EL PASO ELECTRIC 345 KV, SPRINGERVILLE TO DEMING, TRANSMISSION LINE PROJECT

Final Management
Framework Plan
Amendment

Final

**Management Framework Plan Amendment/
Environmental Impact Statement**

FIGURE 1 MODIFIED PROPOSED ACTION

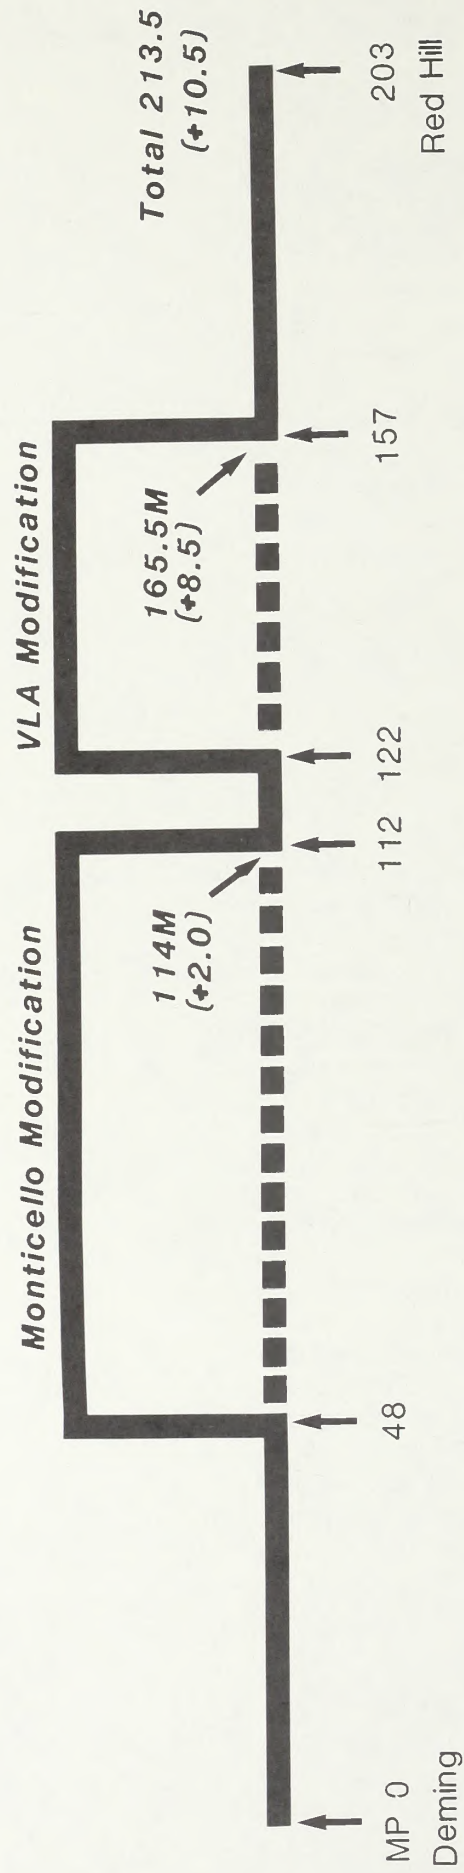
The Proposed Action as described in the draft MFPA/EIS has been modified by El Paso Electric Company (Letter 24, Section 4) in two locations: (1) Monticello Canyon and (2) Very Large Array. These modifications would increase the length of the Proposed Action by 2 and 8.5 miles respectively, for a total increase of 10.5 miles. Figure 1 shows the differences between the original and modified routes and Map 1-2 of the draft MFPA/EIS was modified accordingly. (See Section 3 for changes to the draft MFPA/EIS.) With the modifications, the Proposed Action would now be 213.5 miles long, disturb 640.5 acres, and cost about \$34,276,000 to build. The modified Proposed Action would cross 66.9 miles of public land (Modified Map 1-2, Section 3).

The Very Large Array (VLA) modification would start at MP 122 of the original Proposed Action route, head northwest until it intersected the Plains of Agustin. From there, it would turn north for about 12 miles, crossing State Highway 12. From that point, the route would head west and a little south for about 20 miles where it would turn to the northwest, intersecting the original route at MP 157. The route is mileposted from 122 to 165.5M and is 8.5 miles longer than the original route (Modified Map 1-2, Section 3).

The revised location would not likely interfere with the existing operation of the VLA, even though the modified location is approximately 2 miles closer to the end of the southwest arm of the VLA. The modified route would be shielded by several points of higher elevation, so no direct line of sight interference would occur. However, vertical interference may occur (little is known at this time about vertical interference). The probability of any interference could be reduced by employing the following measures for about 2 miles on either side of MP 127.7: (1) using a larger conductor and (2) using corona rings around the hardware where the insulator string attaches to the two-conductor bundle. These steps, along with a well-designed insulator string, should reduce electromagnetic interference to an acceptable level. This modification would still preclude any extension of the southwest arm of the VLA.

FIGURE 2 MODIFIED VERY LARGE ARRAY ALTERNATIVE

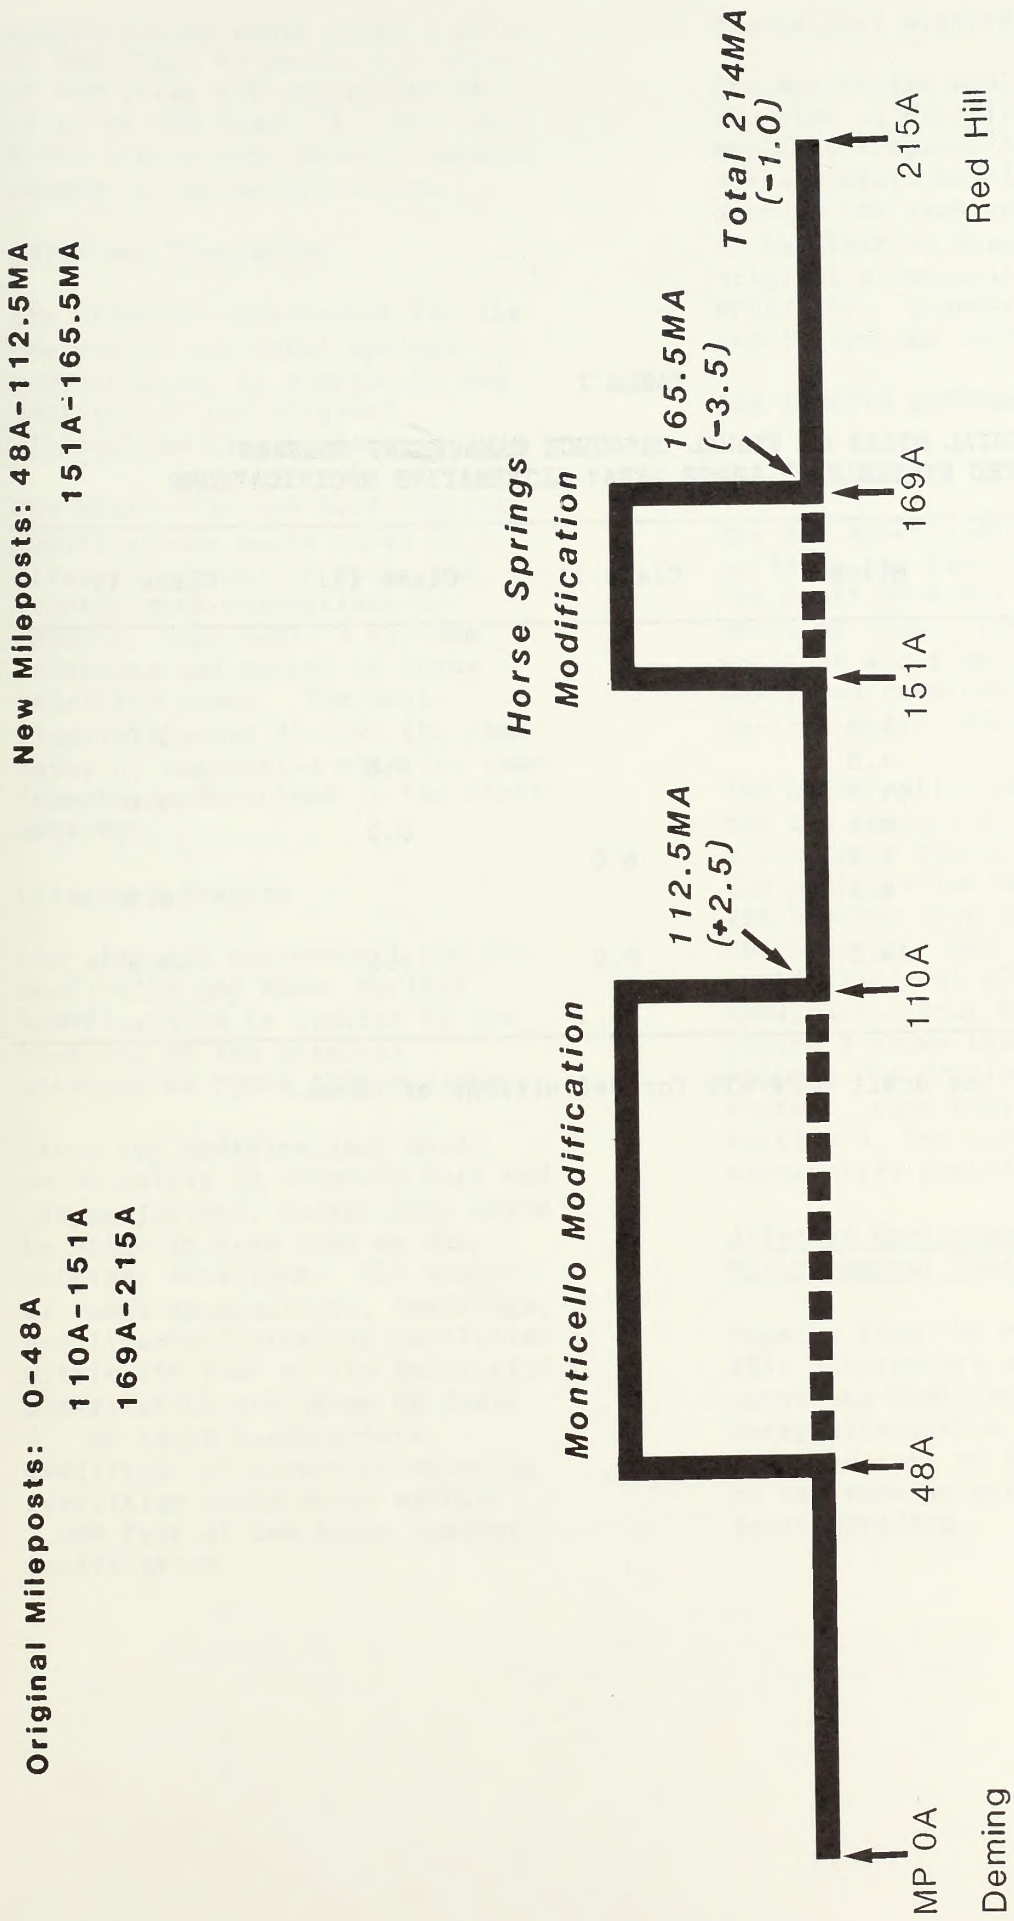
The Very Large Array Alternative (A) as described in the draft MFPA/EIS has been modified in two locations: (1) Monticello Canyon and (2) Horse Springs. These modifications would change the length of the alternative by more than 2.5 miles and less than 3.5 miles respectively, for a total change of less than 1 mile. Figure 2 shows the differences between the original and modified routes. (See Modified Map 1-2, Section 3, for changes along the alternative route.) With these modifications, the alternative would be 214 miles long, disturb 642 acres, and cost about

The Horse Springs modification would start at about MP 151A of the original alternative route, head north, then northwest, until it intersected the original alternative route at MP 169A. The route is mileposted from 151A to 165.5 MA and would be 3.5 miles less than the original sections (Modified Map 1-2). Construction of these modifications would be the same as described for the Proposed Action in the draft MFPA/EIS.

FIGURE 3 MODIFIED SAN AGUSTIN ALTERNATIVE

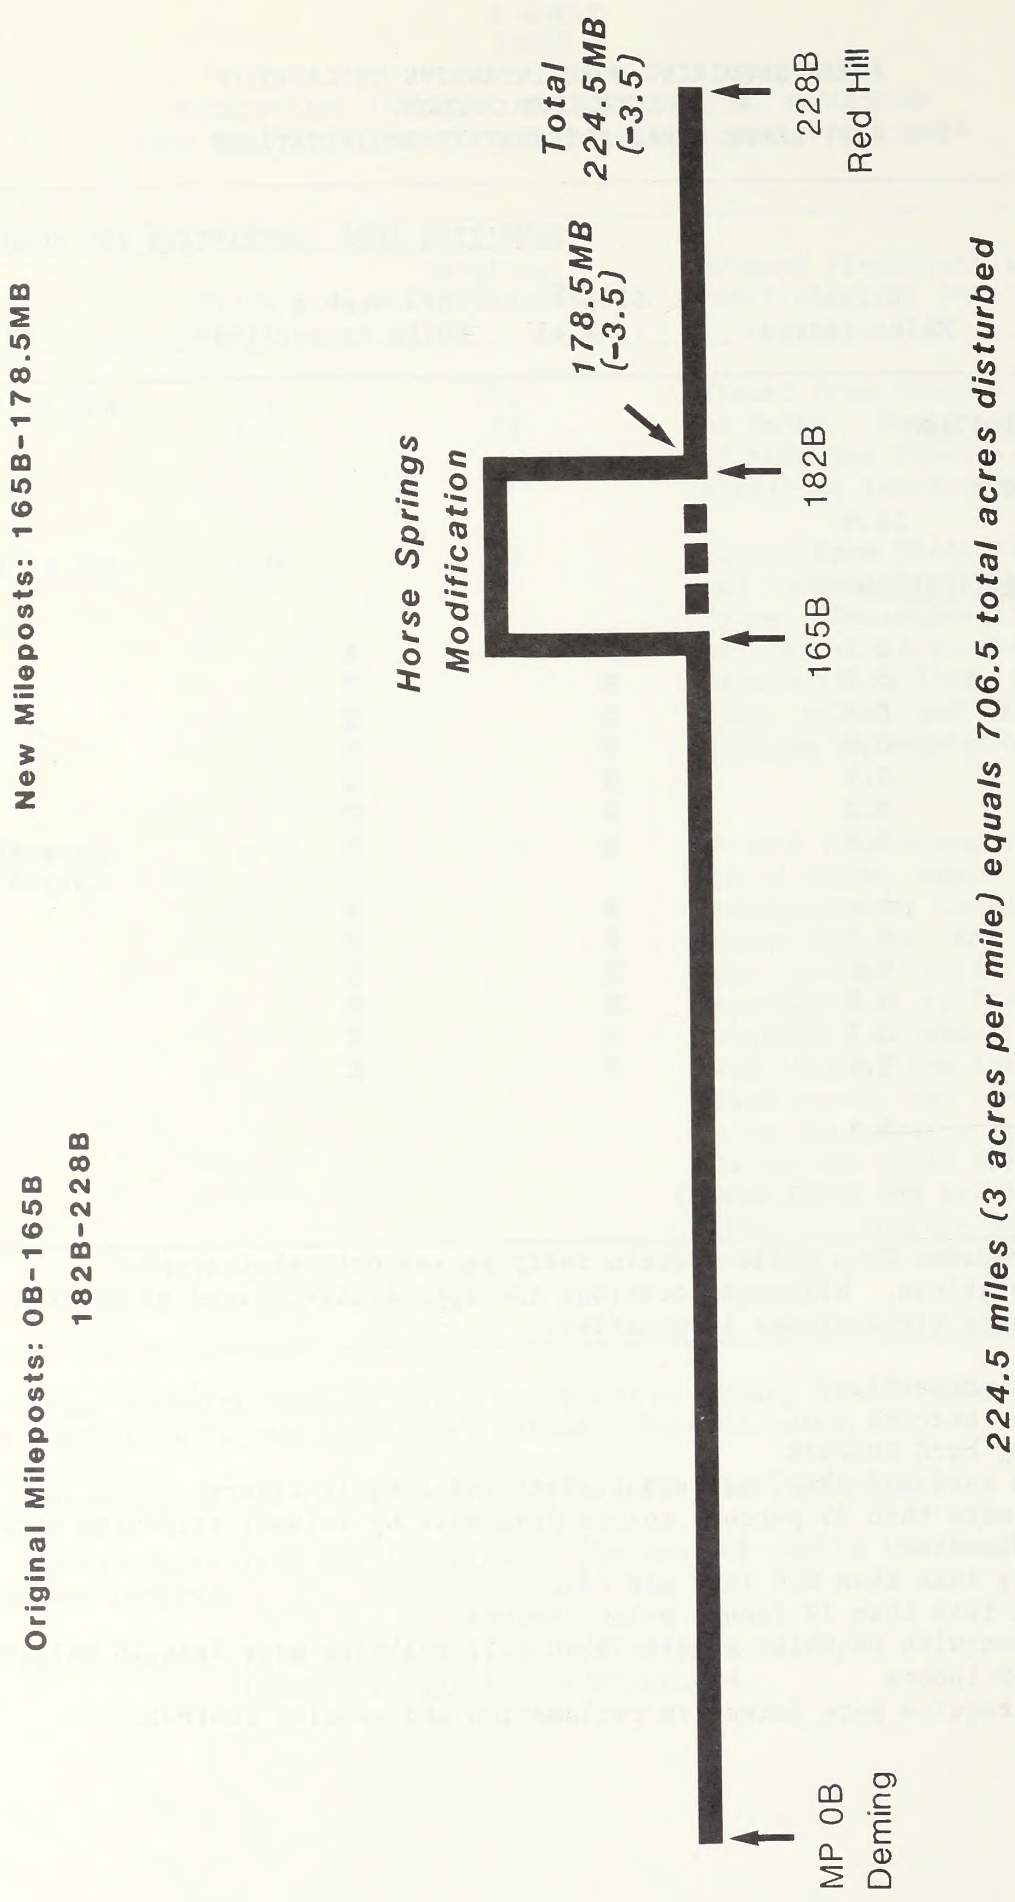
The San Agustin Alternative (B) would be the same as described in the draft MFPA/EIS from MP 0 to about MP 165B. From there, it would be modified the same as described previously as the Horse Springs modification.

The modification would shorten the San Agustin Alternative by 3.5 miles. The alternative with the modification would now be 224.5 miles long and disturb 706.5 acres. The alternative would also cost slightly less to construct--about \$42,385,000. Figure 3 shows the differences between the original and modified routes. (See Modified Map 1-2, Section 3, for changes along the alternative route).

MAP 1-2M ROUTE MODIFICATIONS TO THE EL PASO TRANSMISSION LINE PROJECT

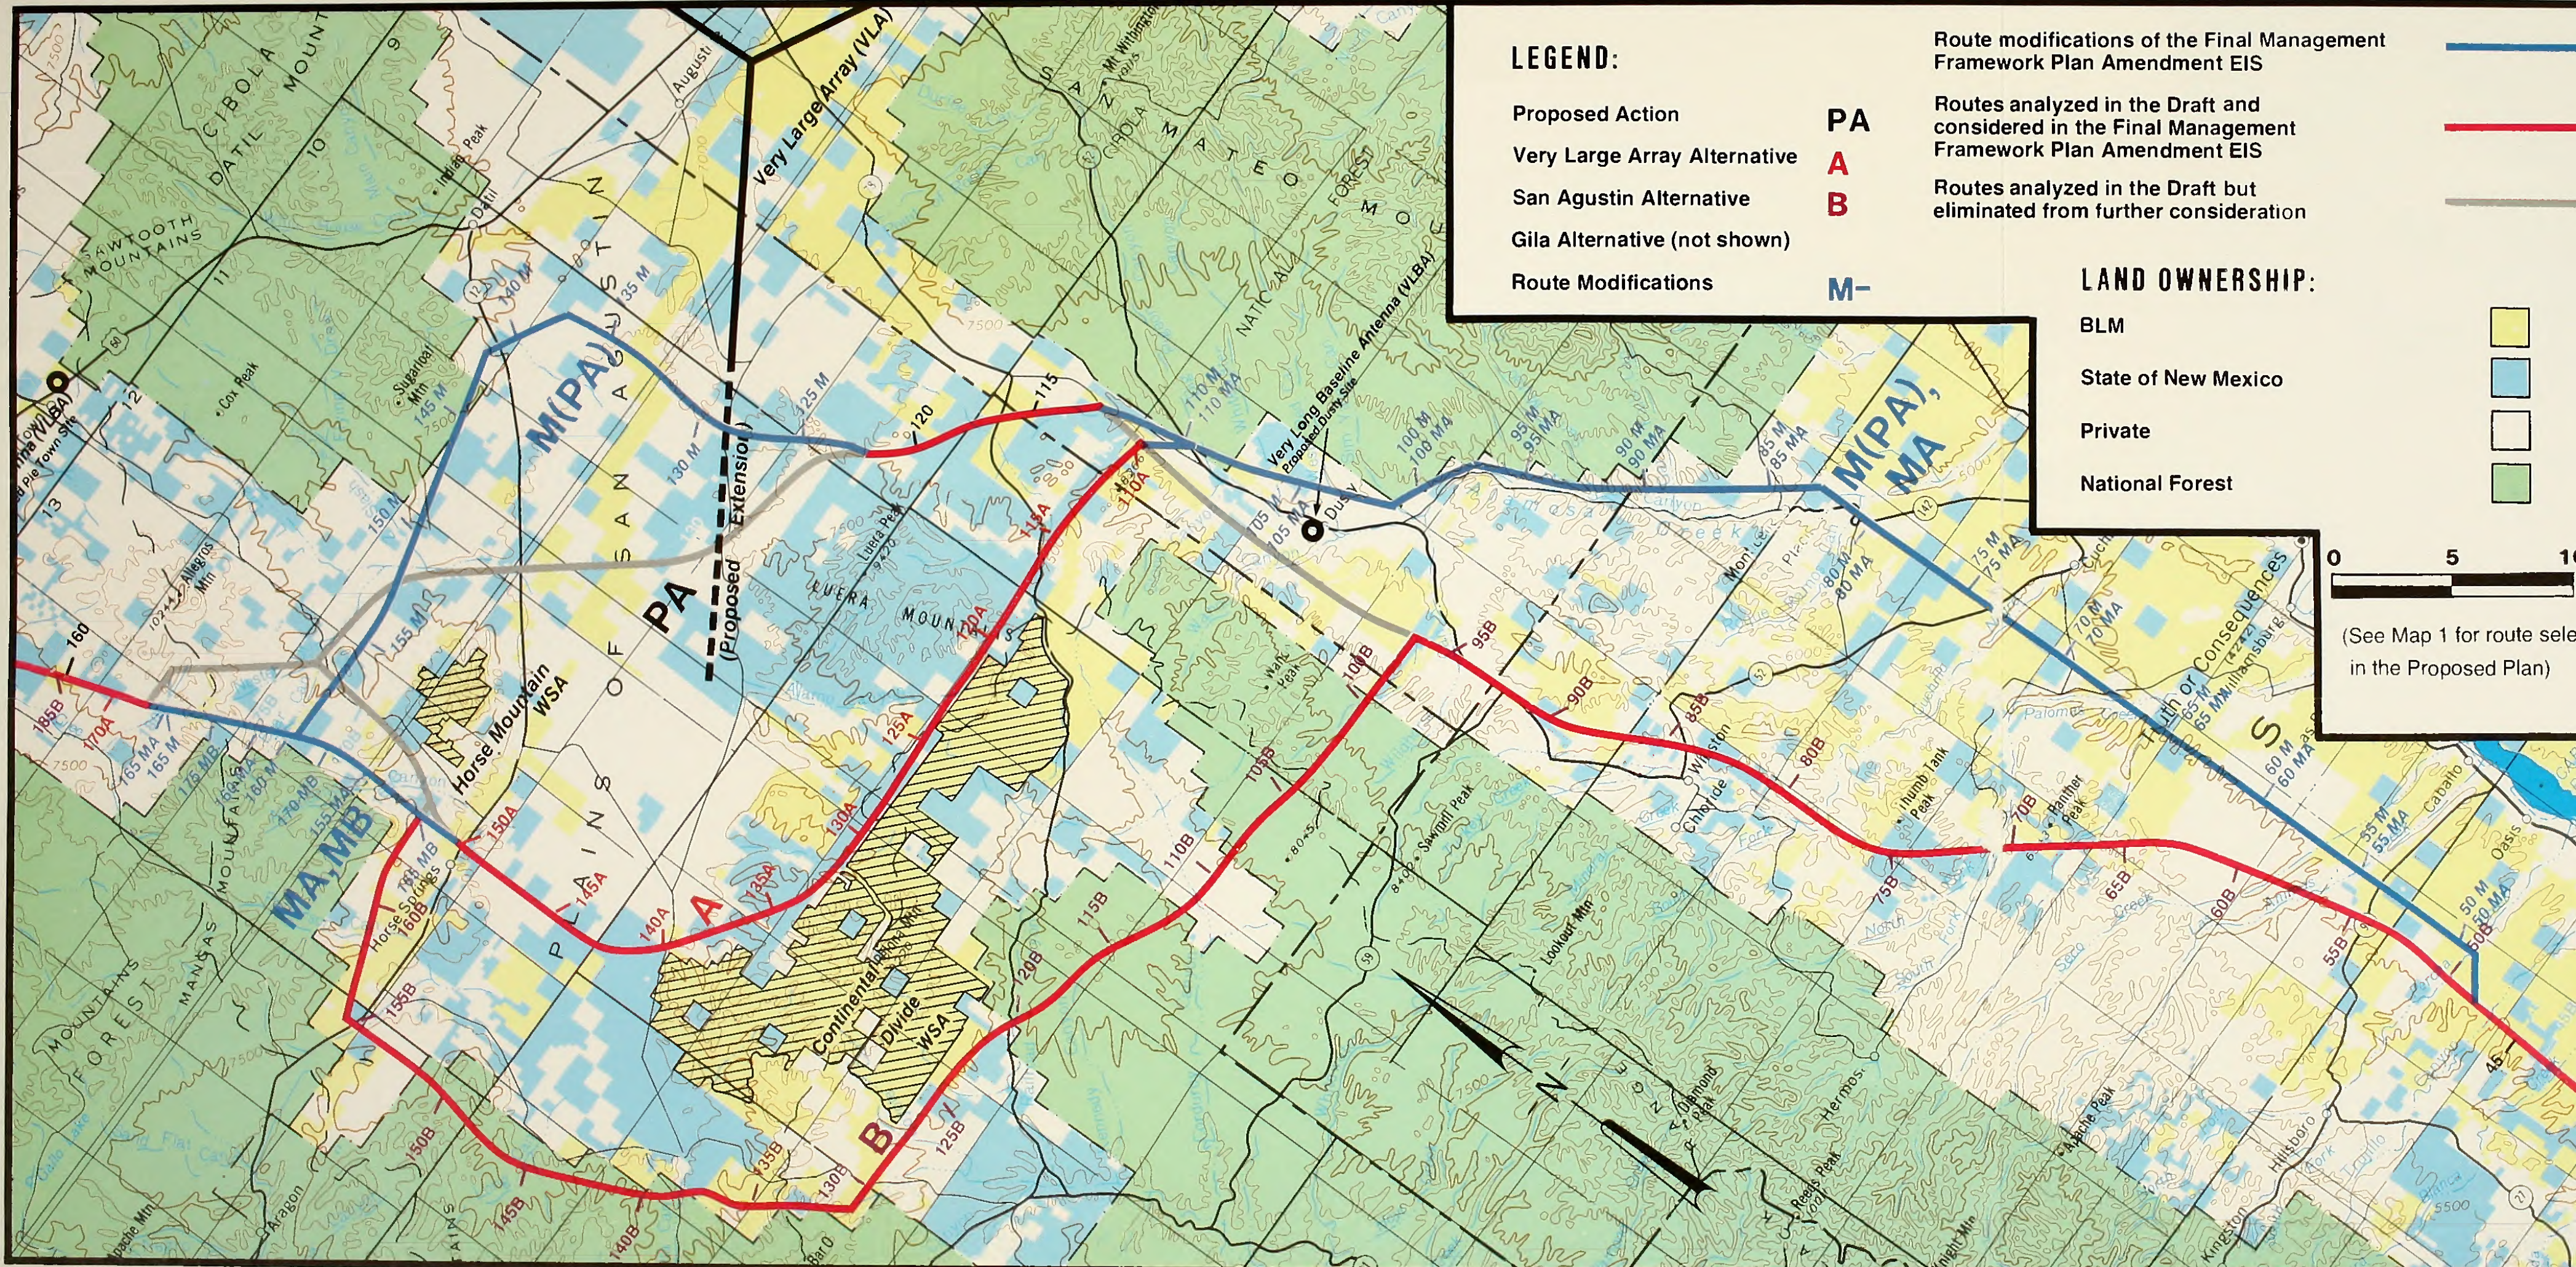
\$34,338,000 to build. This alternative would cross 61 miles of public land. (See Modified Map 1-2, Section 3, for land ownership chart.)
